## Product Change Notice (PCN)

**Subject:** Carrier tape change for Intersil Product ISL98611II56Z-T WLCSP Packaged Product

**Publication Date:** 7/15/2015

Appendix A – Carrier Tape Dimension – PCN15038

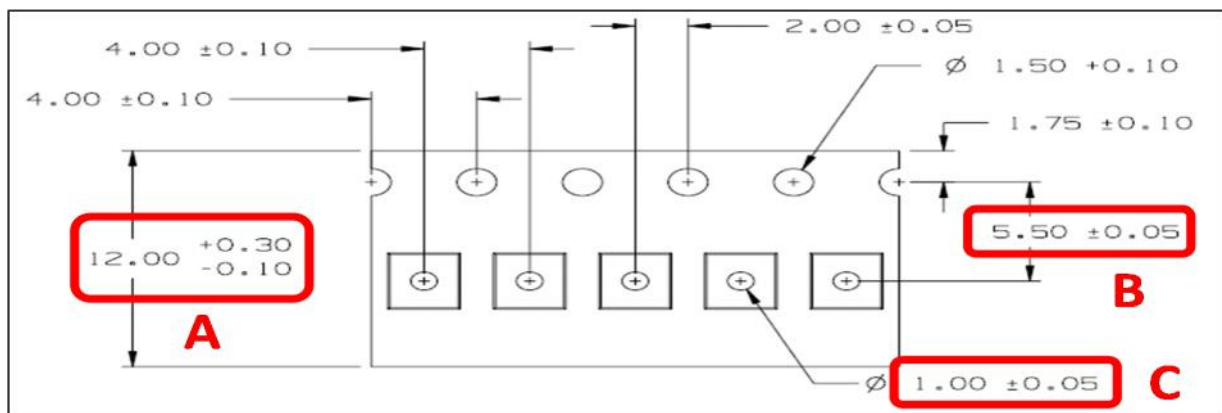
Existing Carrier tape (8mm)

New Carrier tape (12mm)

#	Code	Dimension	Existing Carrier Tape	New Carrier Tape
1	A	Carrier Tape Width	8.00 mm + 0.30 mm - 0.10 mm	12.00 mm + 0.30 mm - 0.10 mm
2	B	Index Hole to Pocket Hole Width	3.50 mm ± 0.05 mm	5.50 mm ± 0.05 mm
3	C	Pocket Hole Diameter	0.60 mm ± 0.05 mm	1.00 mm ± 0.05 mm
